ADDENDUM #2

Bid No.: 50-00118051 **Bid Opening Date: November 15, 2016**

For: TWO (2) YEAR CONTRACT FOR LABOR AND EQUIPMENT TO MAINTAIN DREDGE INTAKE BASIN AT THE EASTBA NK WASTEWATER TREATMENT PLANT, FOR THE JEFFERSON PARISH DEPARTMENT OF WATER.

HYDROLOGICAL SURVEY OF EAST BANK WATER TREATMENT PLANT INTAKE BASIN METAIRIE
JEFFERSON PARISH, LOUISIANA

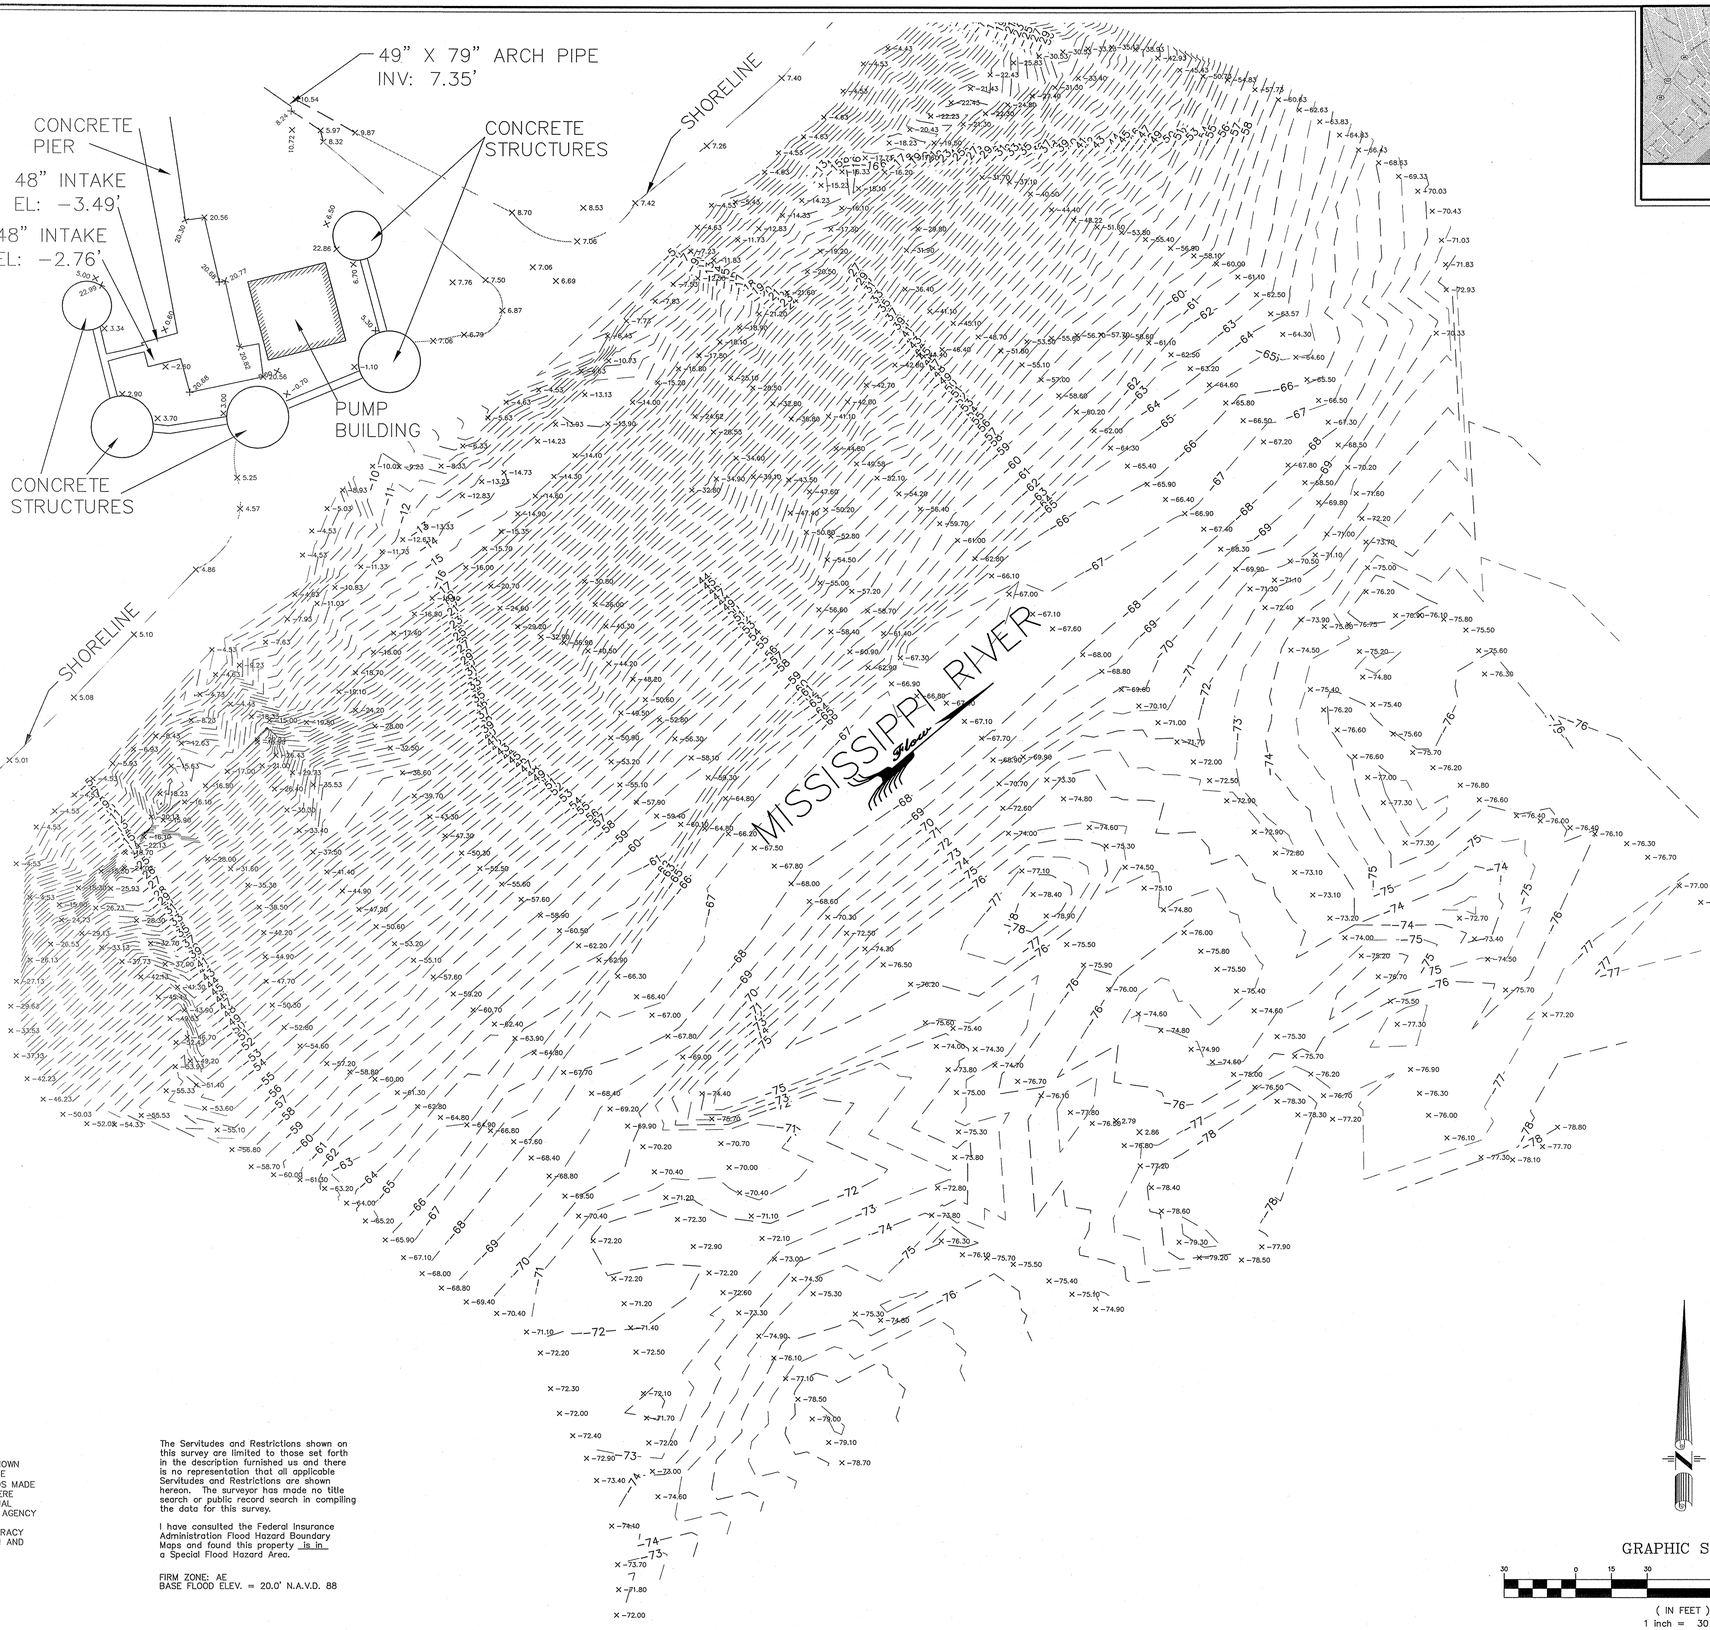
3. Can we get a legible copy of the Hydrological survey? The topo elevations are not legible.

Answer: *Please see the attached PDF. You may be required to zoom in for a clear view.*
